RE: Response to October 9, 2020 USACE Comment Letter, Proposed Big Hollow Wetland Mitigation Bank Project, Sauk County, WI

On behalf of Big Hollow Wetland, LLC, Heartland Ecological Group, Inc. ("Heartland") is providing a summary response to the comments provided in the USACE letter submitted to the bank Sponsor dated October 9, 2020 in response to the review of the draft MBI for the proposed Big Hollow Wetland Mitigation Bank project. The comments will be incorporated into the draft MBI for final review once we reach resolution on addressing the comments. The responses to the comments follow the numbering and order presented in the Corps letter.

CONCEPTUAL GRADING PLAN

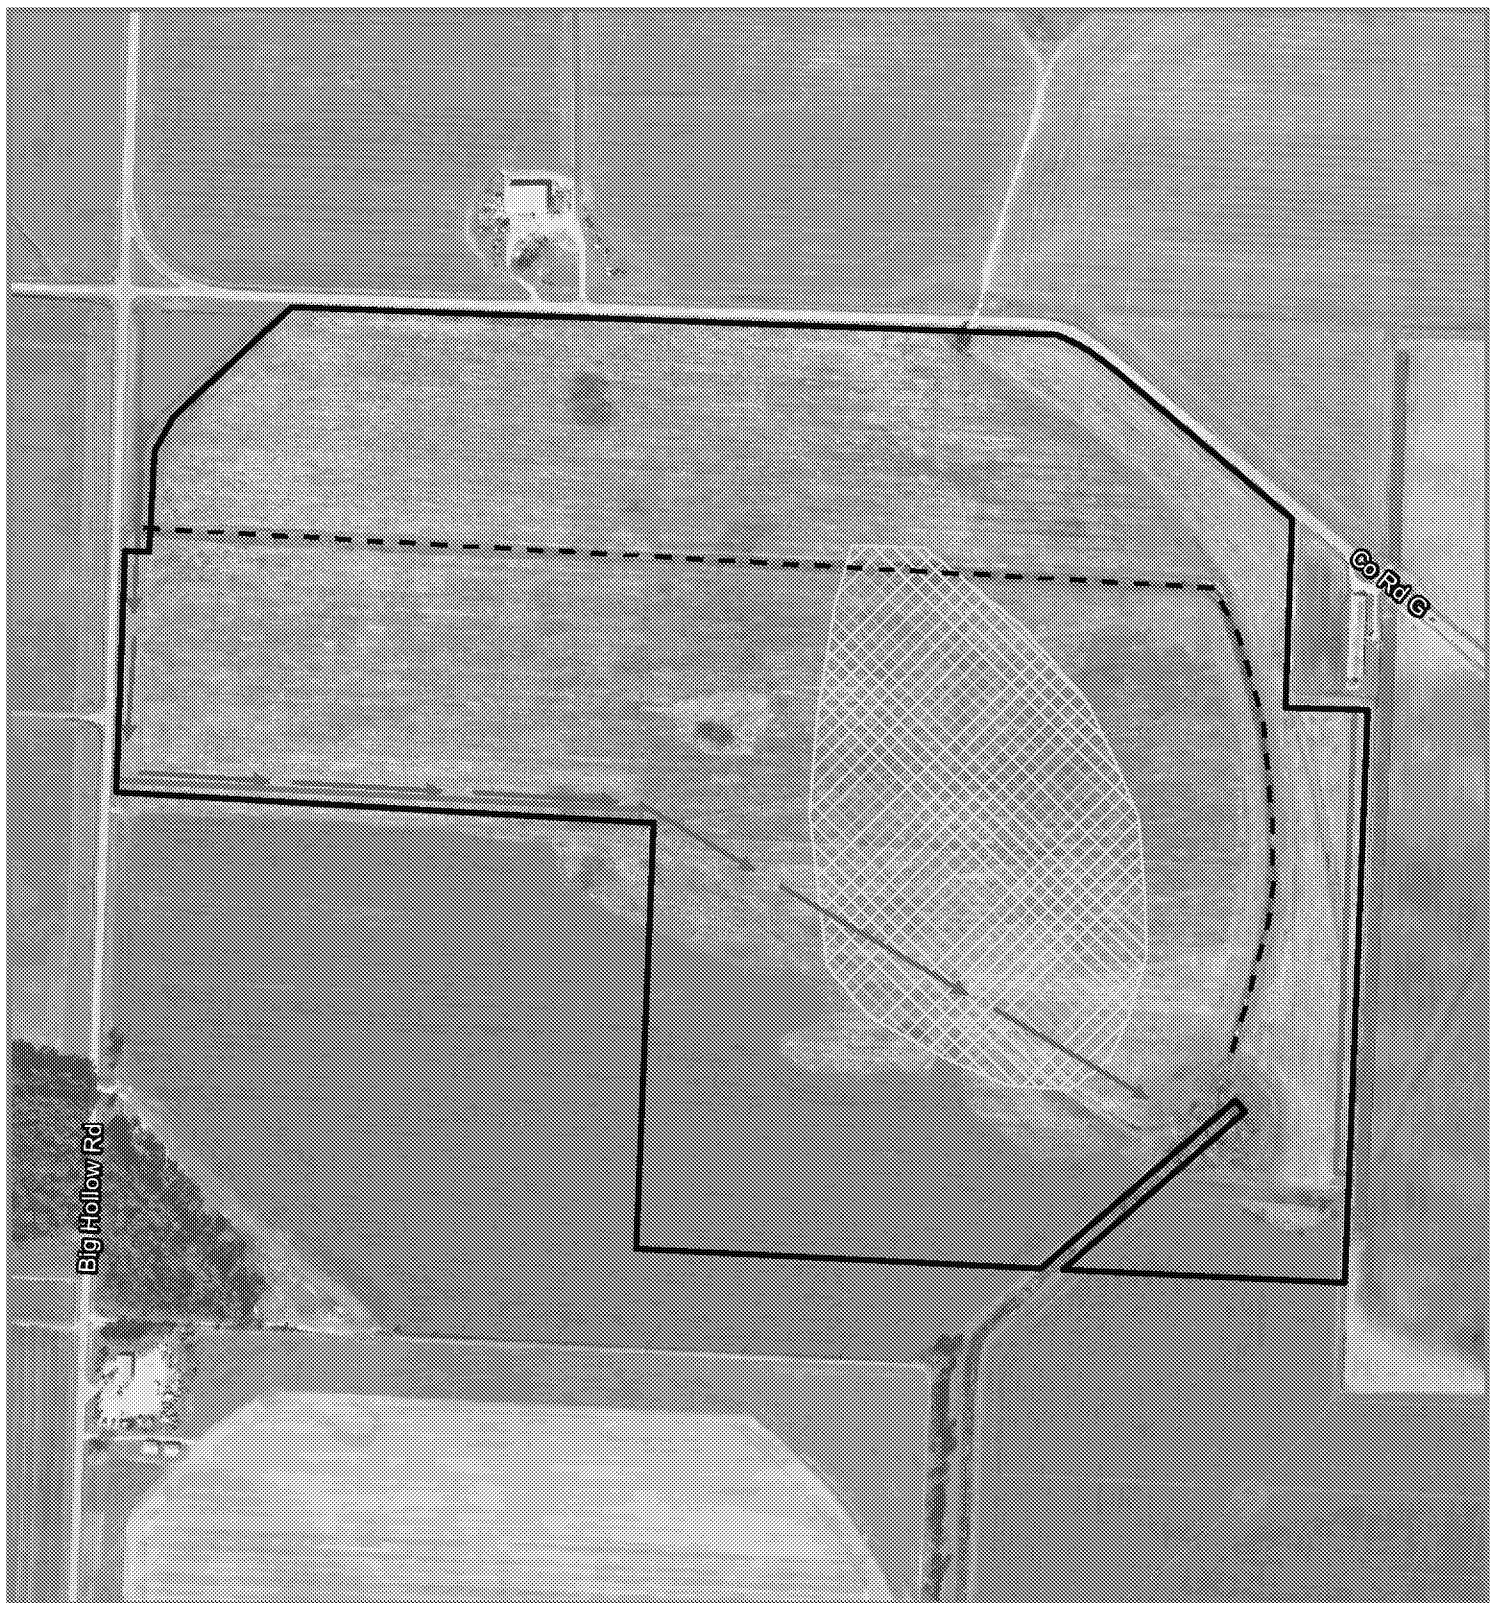
The proposed grading plan has been revised to reflect the IRT's recommendation to reduce the overall extent of scraping and to limit the size and depth of individual scrapes. A revised grading concept plan is attached, and detailed engineering drawings will be submitted with the draft MBI. The extent of scraping has been cut approximately in half to 30 ac. The upper 2 inches of soil will be scraped off throughout the 30 acres, with small areas (approximately 0.1 ac) deepened to 6 inches dispersed throughout and comprising 25% of the total scrape area. This will facilitate hydric soil development, distribute surface runoff more widely, and limit the size and depth of inundation.

The scraping will be focused in the southeastern part of the site to expand the current pattern of inundation from upstream runoff as it traversed the site from northwest to southeast. Earthwork cut will be limited to the extent of the scrape shown on the attached concept plan, and placement of fill will be limited to filling the ditch and constructing the berms as shown on the plan. Earthwork cut and fill balances in the attached plan. No other borrow or fill areas are proposed.

**Figure 10a. Irrigation
Well Location and
Setbacks**

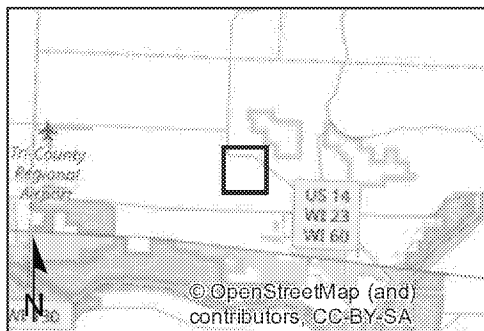
Groundwater drawdown was evaluated at the end of the irrigation season (maximum drawdown) using the standard Theis method (see pages 22 – 27 and Appendix B of the draft MBI). Drawdown was evaluated at distances from the

well of 500 ft (in the center of the wetland mitigation area) and 1500 ft (including most of the mitigation area). As the table below shows, drawdown for the proposed conditions is only 0.1 ft and 0.06 ft at distances of 500 ft and 1500 ft, respectively. Figure 10a attached illustrates these radii at the site.

Figure 11. Wetland Compensation Types

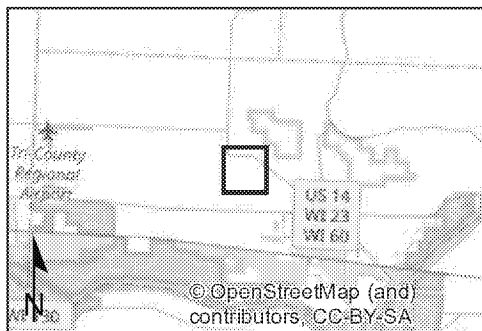
The areas of nonhydric soils that are proposed for wetland credits have been reclassified as wetland establishment (Figure 11). However, the Sponsor proposes a credit ratio of 0.75:1 for the wetland establishment areas. There is no fundamental difference in the ecological benefits provided between the rehabilitation and establishment portions of the wetland and while minor discrepancies within the soils that determine hydric characteristics are present, a mosaic of hydric and marginal nonhydric poorly drained soils lie throughout the project area with nearly no elevation relief. Very limited grading is necessary to achieve the proposed hydrology in the establishment areas, in fact by removing only two inches of the surface soils, many areas will meet hydric soil criteria immediately following construction. This is also supported by the hydrology monitoring and modeling that has been completed and presented previously and is also addressed in response to Comment #3 below.

In response to the IRT's comments regarding compensation types being utilized (point #1) and an additional rehabilitation area that was identified, a revised map figure depicting areas where each respective compensation type is being utilized (Figure 11) and a revised credit table (presented below) have been produced. In addition, a statement that the portion of mitigation credits derived from upland buffer that meet performance standard shall be allocated to the balance of fresh wet meadow credits available for sale shall be added to section 8.0 Determination of Credits of the MBI.

Figure 12. Field Hydric Soil Determination

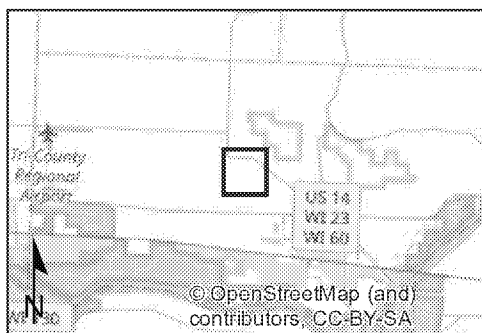
In conjunction with USACE and WDNR staff, Heartland completed a soil evaluation in the early fall of 2020 to identify and map hydric and nonhydric soils. An additional six (6) soil profiles were evaluated within the proposed wetland restoration portions of the site (Soil Data Sheets attached). All soil profiles that were evaluated showed indicators of seasonally high-water tables near the surface such as redoximorphic features and depleted or nearly depleted matrices. This was consistent with soils evaluated during the wetland determination study as well. Soil profiles that met an indicator of hydric soils were limited to the northwestern portion of the wetland restoration areas. Soil profiles that did not meet a hydric soil indicator were very marginal in nature and did not meet hydric soil indicators based on very minor technicalities. For example, at both SP-3 and SP-5 the depleted matrix present was only 2 inches too deep to meet A11. Depleted Below Dark Surface. Saturated soils and a water table were present within 24 inches of the soil surface. Soils evaluated at SP-6 again marginally do not meet a number of hydric soil indicators by minor technicalities but otherwise reflects a poorly drained soil with a seasonally high-water table. Saturated soils were present within 12 inches of the surface. It is apparent that the entire wetland restoration areas support a mosaic of hydric and marginally nonhydric soils given the lack of relief across the site and

evidence of seasonally high-water tables. Nonetheless, a hydric soil boundary was estimated based on the results of the soil evaluation, considering topography and hydrology (Figure 12).
